COMMENT #101

Limit for Cable Assembly Diff-to-Common RL

Bruce Champion,TE

Figure 162-5—Differential to common-mode cable assembly return loss

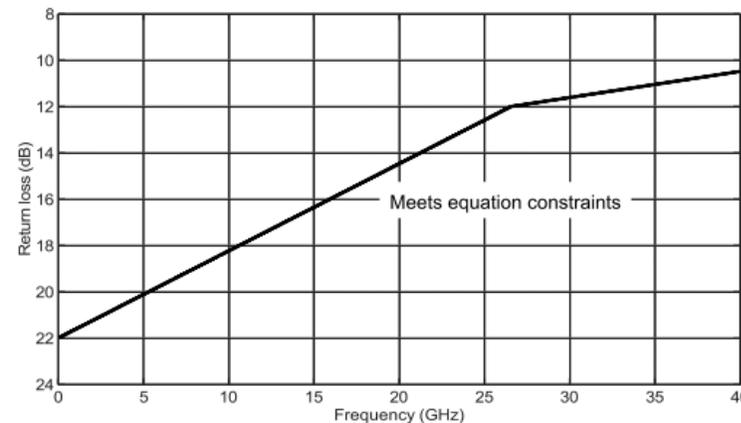
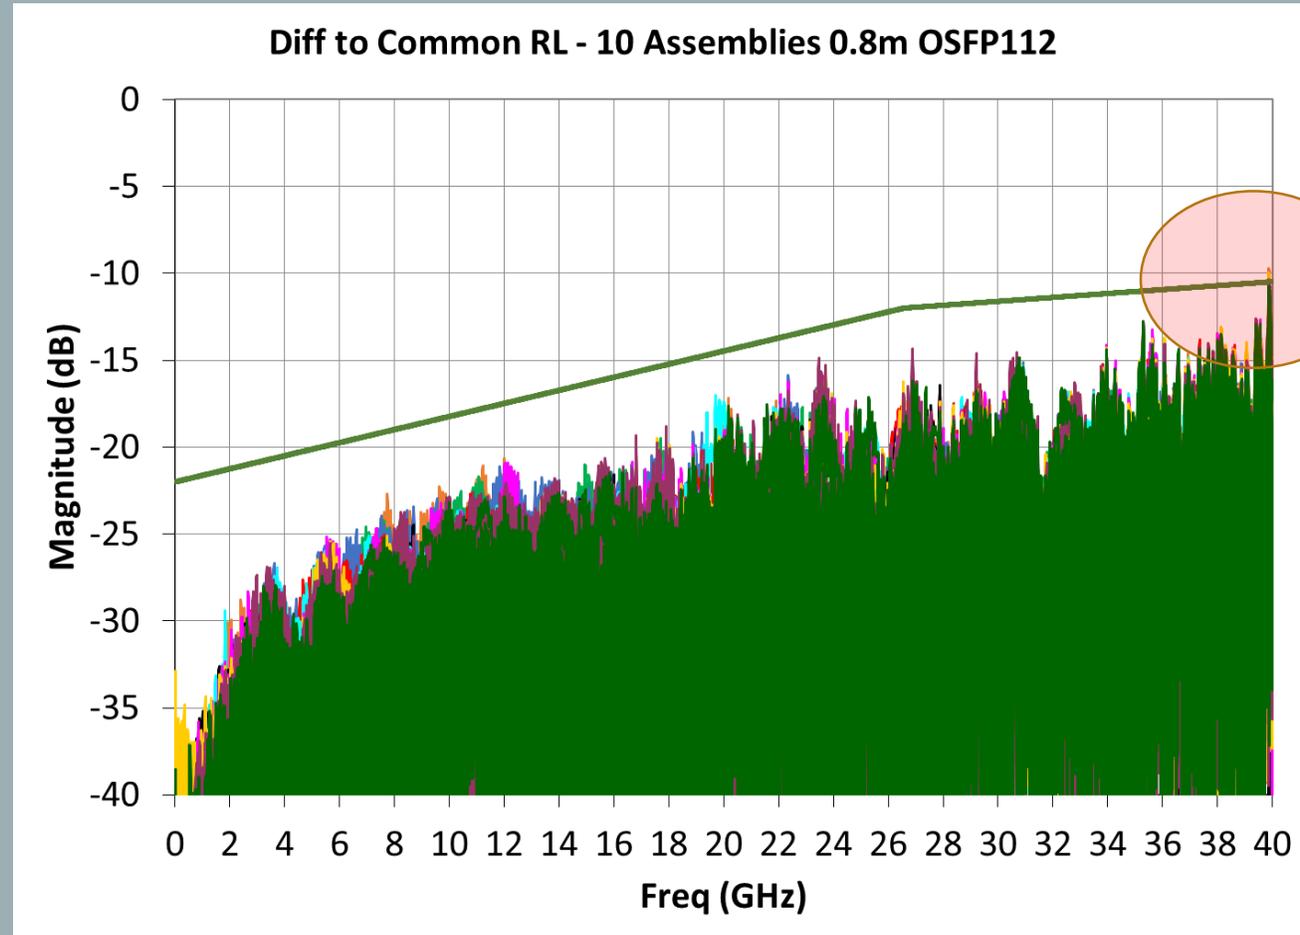
- Comment addresses issues with existing limit expressed in equation 162-9 concerning cable assembly differential to common-mode return loss

- Existing limit is too tight for high-volume production testing
- Production testing will have some testing artifacts due to constant use of MCBs and test points
- Minor issues like this should not be causing assemblies to fail

- Proposed limit adds some extra margin at the higher frequencies to account for some minor wear on module compliance boards during high-volume production

$$\text{Return Loss}(f) \geq \begin{cases} 22 - 10(f/26.56) & \text{for } 0.05 \leq f < 26.56 \\ 19 - 7(f/26.56) & \text{for } 26.56 \leq f \leq 40 \end{cases}$$
